LITWORNIA ASSOCIATES, INC.

Re: West Essex Highlands, Inc. PB 24-01
Township of West Orange, Essex County, NJ
Block 179, Lot 32
LAI 2024-006

RE: RESIDENTIAL SITE IMPROVEMENT STANDARDS (RSIS) – TRAFFIC REVIEW

Figure 1 - Existing Interior Private Roadways

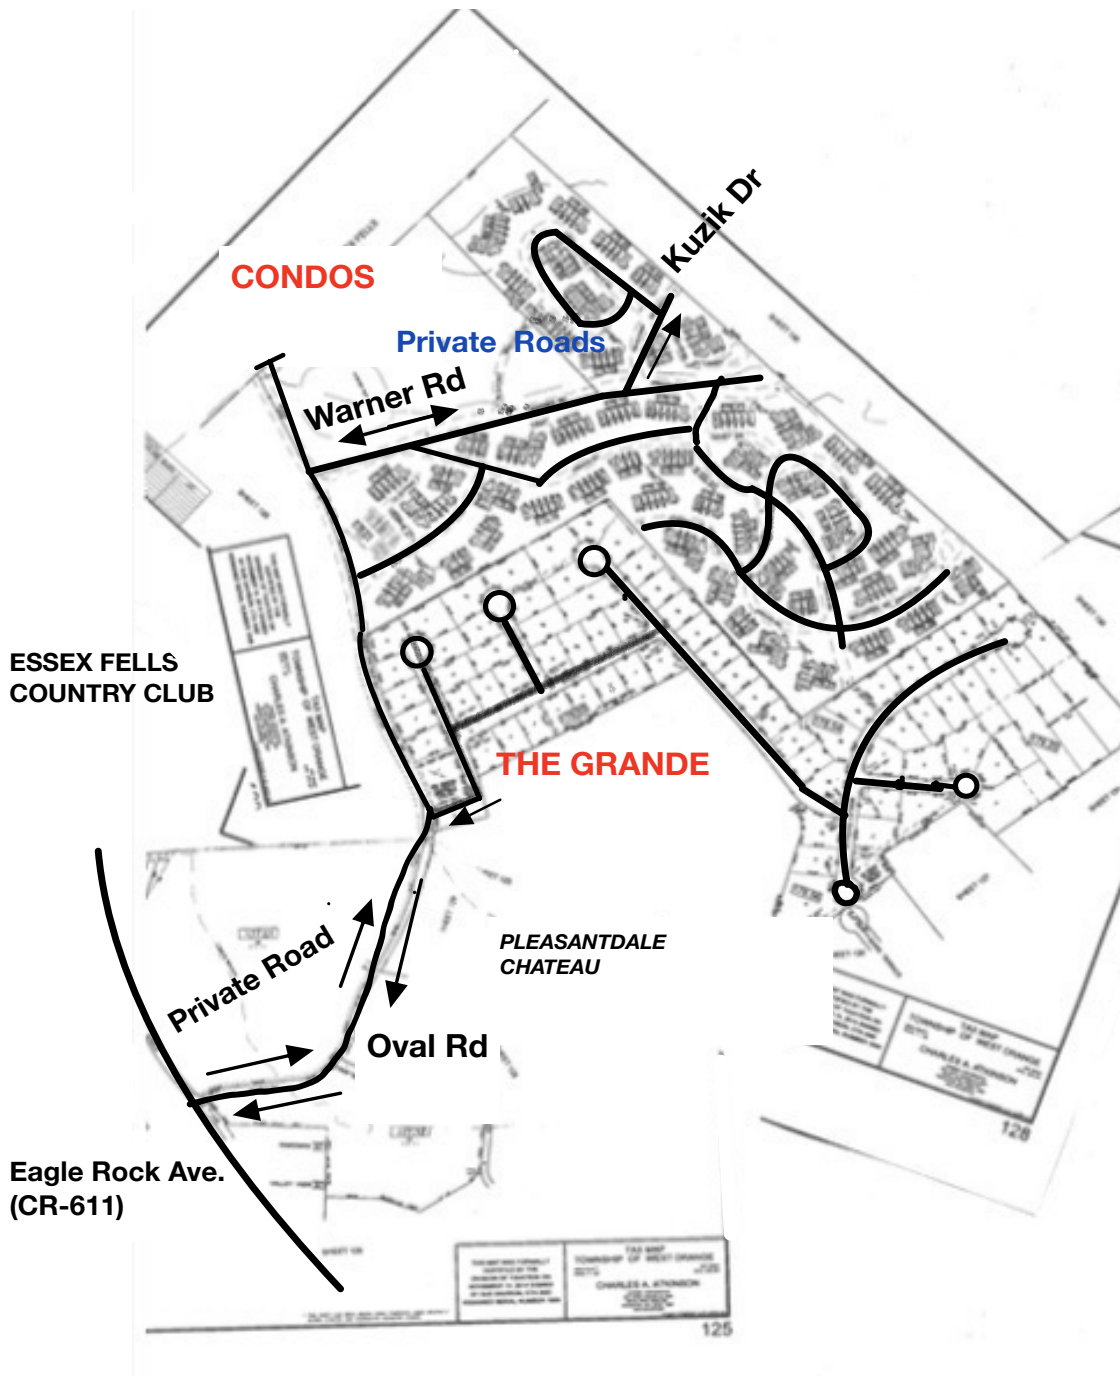
See the existing cul-de-sac accessed by Oval Road from Eagle Rock. Oval Road is private on the West Orange tax maps and Eagle Rock is a major collector. All other roads depicted are private residential streets of lowest hierarchy.

A review of the development quickly points out that this development is not only a large cul-de-sac that violates the RSIS definition of a cul-de-sac as explained above, but the entire area with only one way in and one way out via Oval Road to the intersection of Oval Road and Eagle Rock Avenue creates in effect, a much larger cul-de-sac. In this instance, the various interconnected streets in the development form one large cul-de-sac since there is only one way in and out of the various developments via Oval Road. Thus, the expansion of a new cul-de-sac within another cul-de-sac will exacerbate an already tenuous situation and is not recommended to utilize Kuzik Drive. Kuzik Drive is private and is simply a branch off Warner Road, which is an extension of Oval Road allowing access to 300 housing units. When questioned, the applicant's traffic engineer stated that if there was an accident on Oval Road "They would be impeded until it was cleared." See page 88 of traffic engineer's PB testimony.

Figure 2 - Average Daily Trips (ADT)

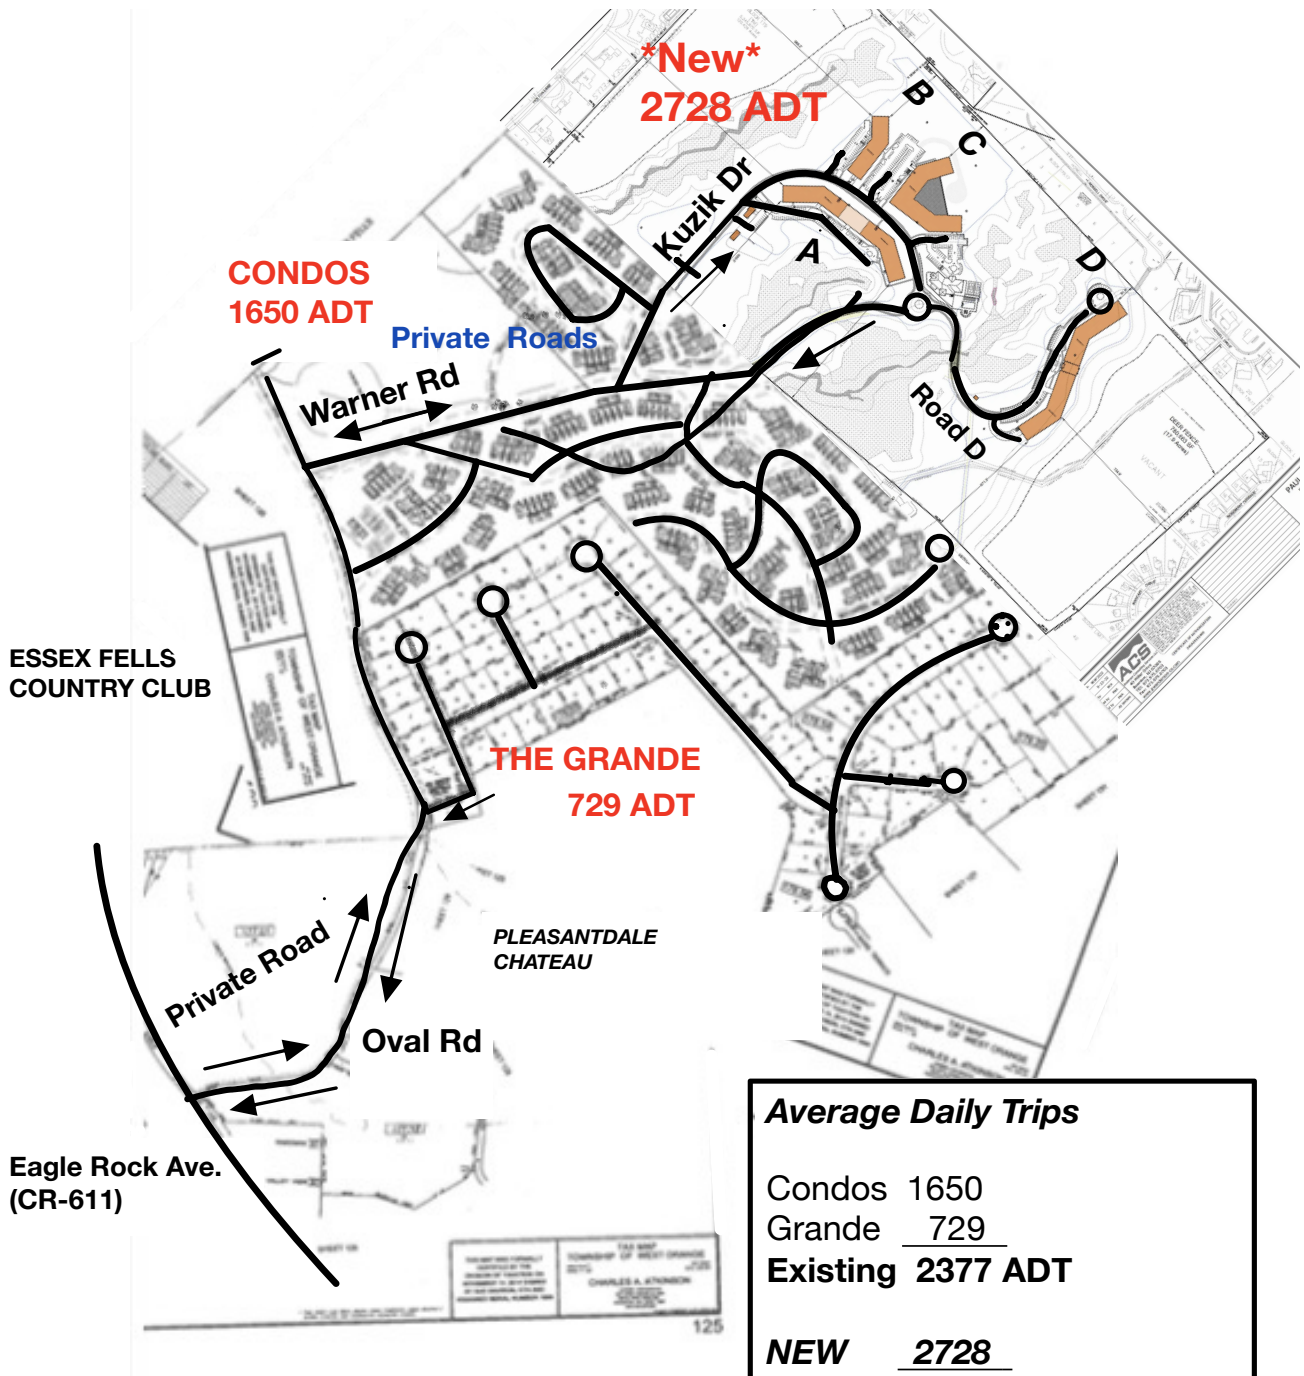
Warner Road extended to the circle shown on drawing SP-29 also has severe slopes inconsistent with RSIS Table 4.6. In addition Warner Road collects all the traffic from Buildings A, B, C, D, and the clubhouse. The traffic from this extension of Warner Road is added to the existing traffic ADT of 1650 from 300 residential units already serviced by Warner Road and Oval Road exclusively. We also add the 72 single family homes in The Grande with 727 ADT accessing Oval Road. The combined total ADT of 5,105 greatly exceeds RSIS standards of 1000 ADT on a multi-unit cul-de-sac and further adds to Oval Road and Eagle Rock Road intersection traffic and degrades the levels of service. Additional traffic generated by Pleasantdale Chateau catering facility with approximately 300 parking spaces is unaccounted for. See the marked up modified tax map of the area.

Existing (2377) + WEHI Proposed Development Total = 5105 ADT

Average Daily Trips	
Condos	1650
Grande	729
Existing	2377 ADT
NEW	2728
Total	5105 ADT

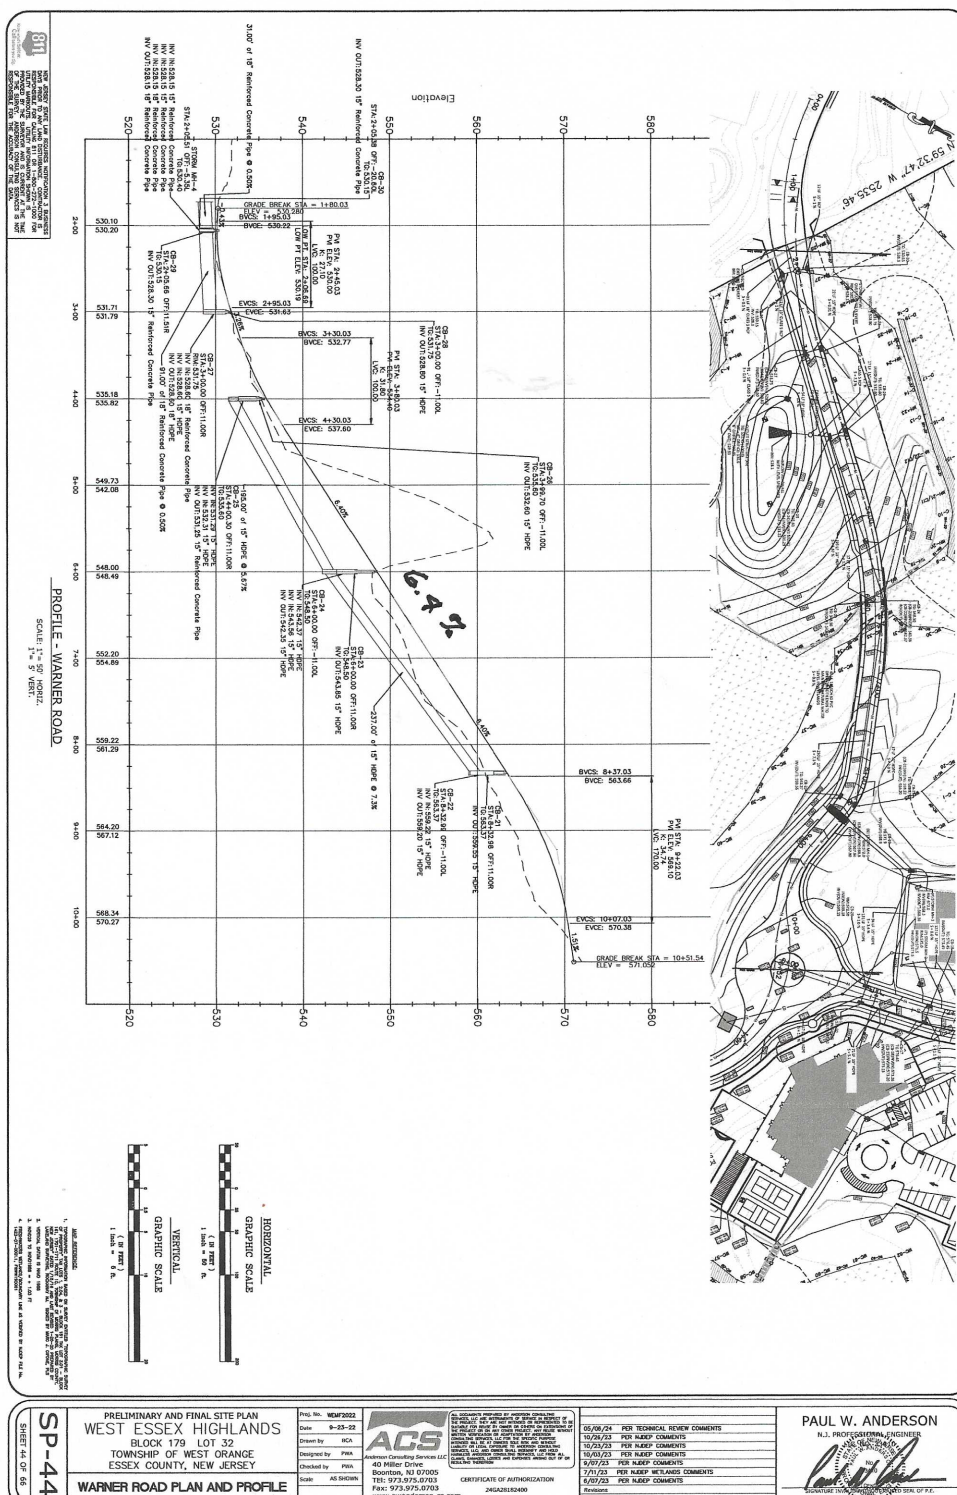
Warner Road extended to the circle shown on drawing SP-29 also has severe slopes inconsistent with RSIS Table 4.6, but in addition Warner Road collects all the traffic from Buildings A, B, C, D, and the clubhouse. The new traffic from this extension of Warner Road is added to the existing traffic from 300 residential units already serviced by Warner Road exclusively. The combined total ADT exceeds RSIS and further adds to Oval Road and Eagle Rock Avenue.

7. Warner Road has steep sloped area and as the only access to residential units and may become impassible in winter when it ices up. Emergency equipment has difficulty climbing steep grade. Vehicles cannot stop at the driveway on this slope.

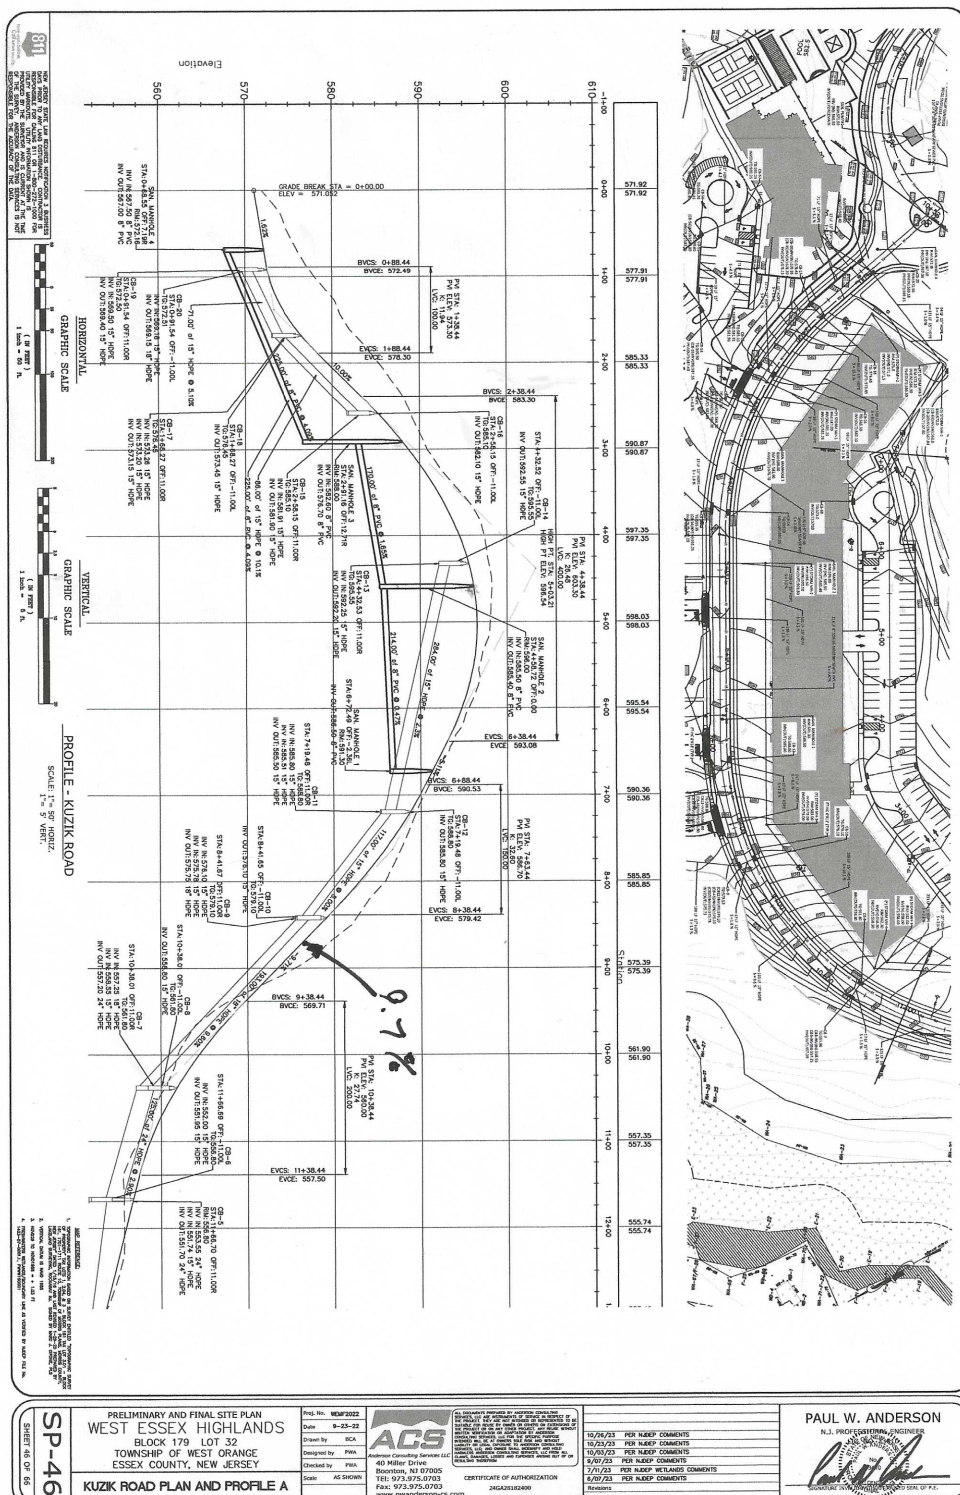
The Kuzik Drive profile on drawing SP-46 has slope of 9.7%, also near to the intersection of the driveway into Building "A". Since Kuzik Drive is so sloped then the driveway into the outdoor parking area must be sloped just as much to meet. Both conditions are safety issues especially the intersection with Kuzik Drive.

Kuzik Drive profile on SP-46 has slope of 9.7% also near to the intersection of the driveway into Building “A”. If Kuzik Drive is so sloped, then the driveway into the outdoor parking area is likely sloped just as much. Both conditions are safety issues, especially the intersection with Kuzik Drive. All driveways and intersecting roadways should have a maximum slope of 5% and be level for 100 feet from the intersection in each direction.

4. Sidewalks don't comply with ADA slope requirements limiting slope to 5%, many areas are at or near 10% which is dangerous for wheel chairs. This occurs on Road D, Kuzik Drive and Warner Road in places. See SP-46, 47, 48 attached.

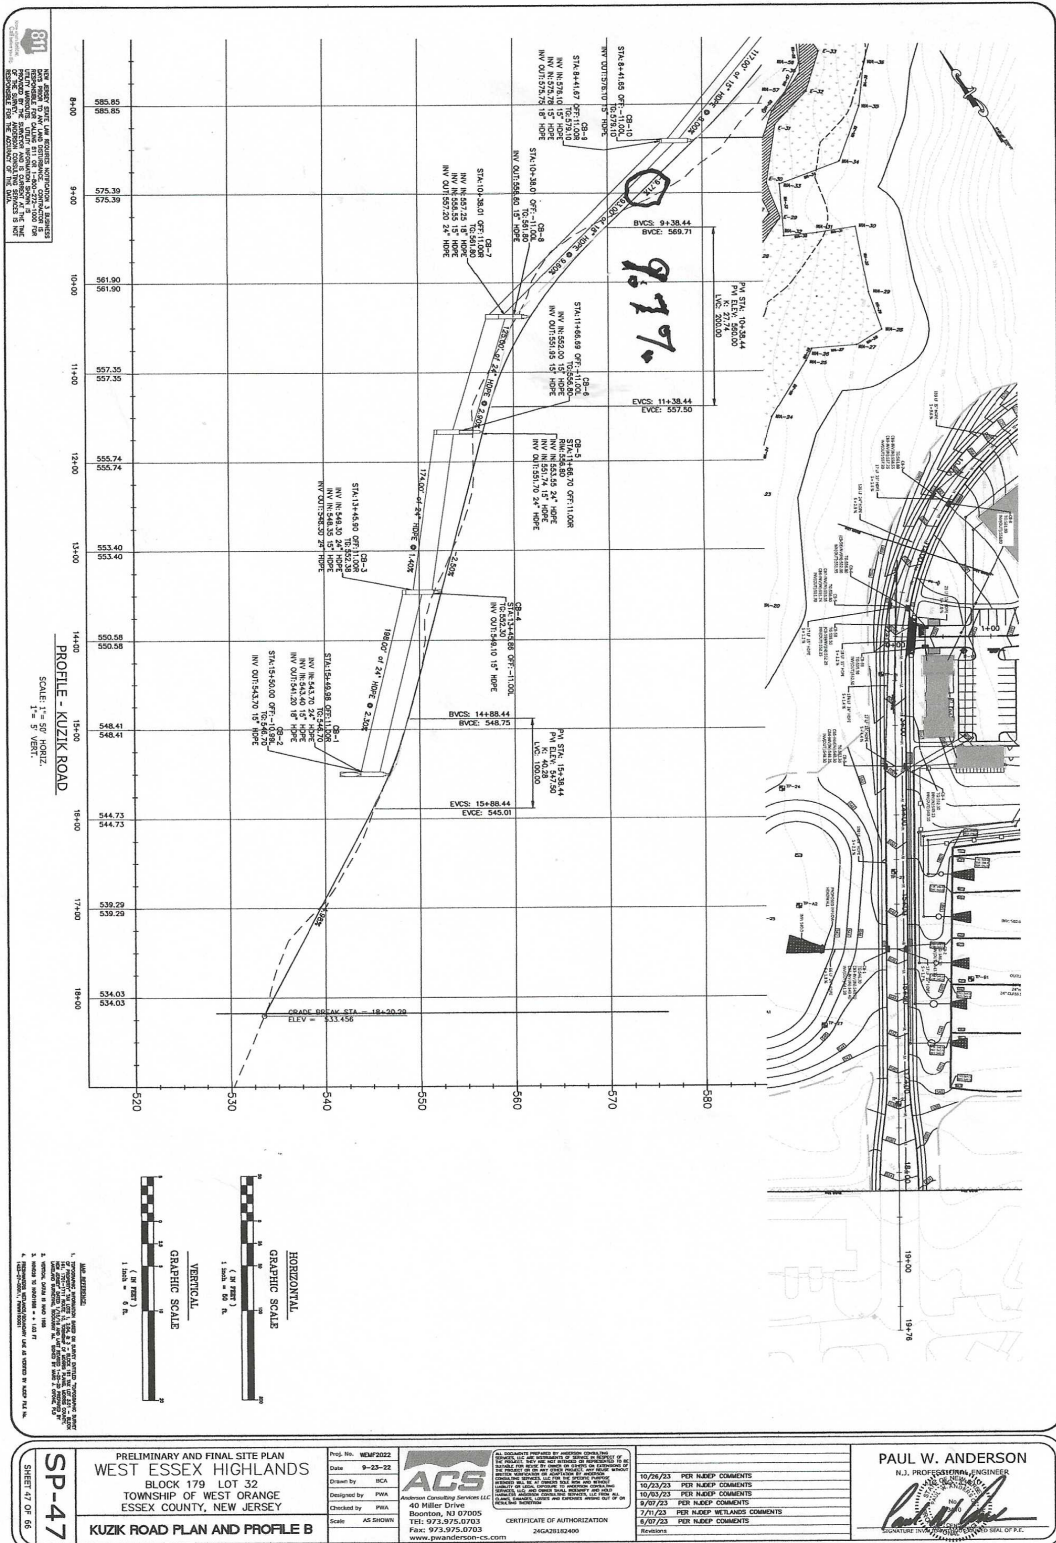
Kuzik Drive which runs past building “C” and “B” also has an intersection slope violation at the entrance to parking area of Building “B” where Kuzik is sloped 9.7% based on drawing SP-47 Profile.

Kuzik Drive which runs down to the existing condominium community is also severely sloped as seen on drawing SP-47. Drainage storm water will flow down this paved slope like a waterfall flowing past the inlets to the basins and cause flooding in the existing neighborhood. Without Kuzik Drive extended there is reported flooding from the natural terrain. Warner Road has a similar issue with storm water despite the many basins and drainage pipes.

Kuzik Drive which runs past building “C” and “B” also has an intersection slope violation at the entrance to parking area of Building “B” where Kuzik is sloped 9.7% based on drawing SP-47 Profile.

Kuzik Drive which runs down to the existing condominium community is also severely sloped as seen on drawing SP-47. Drainage stormwater will flow down this paved slope like a waterfall and cause flooding in the existing neighborhood. Warner Road has a similar issue with stormwater despite the many basins and drainage pipes.

6. Road slope on Kuzik Drive has at or near 10% slope and also passes parking entry/exit on the slope at building A this is dangerous during icy conditions. See drawing SP-47 attached.

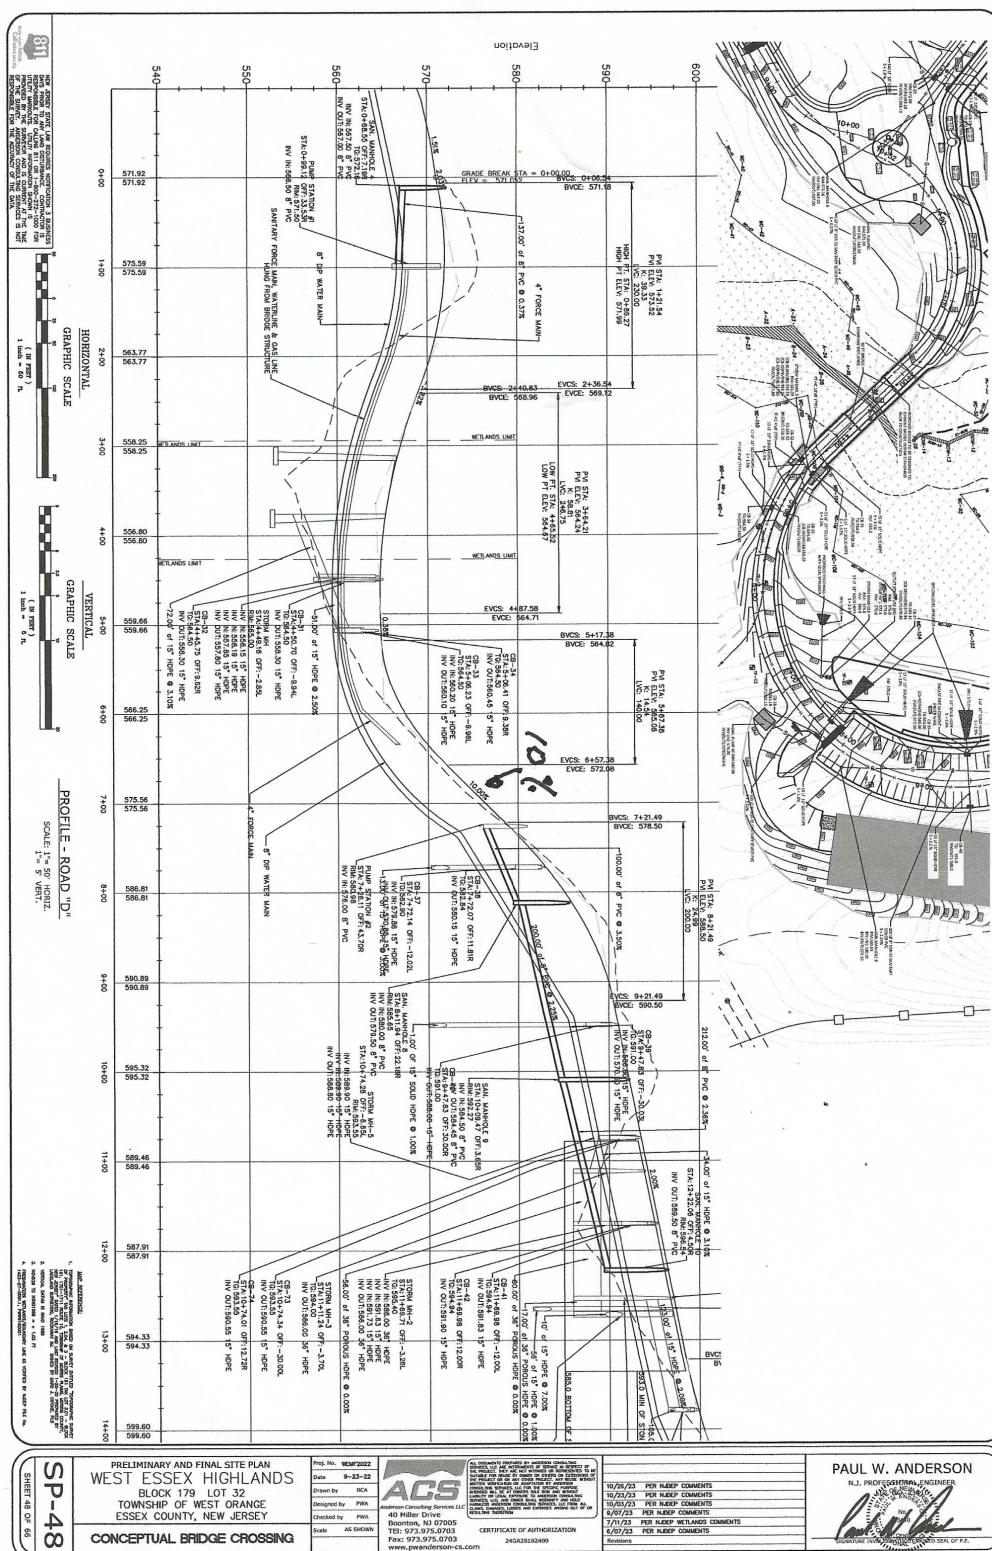
2. * Parking on Road D is dangerous as the sight distance on the curve is too short. See attached drawing SP-48.
3. ADA requirements on all roads specifies 5' sidewalk sections every 200' or less and sidewalks on both sides of street, this is missing.
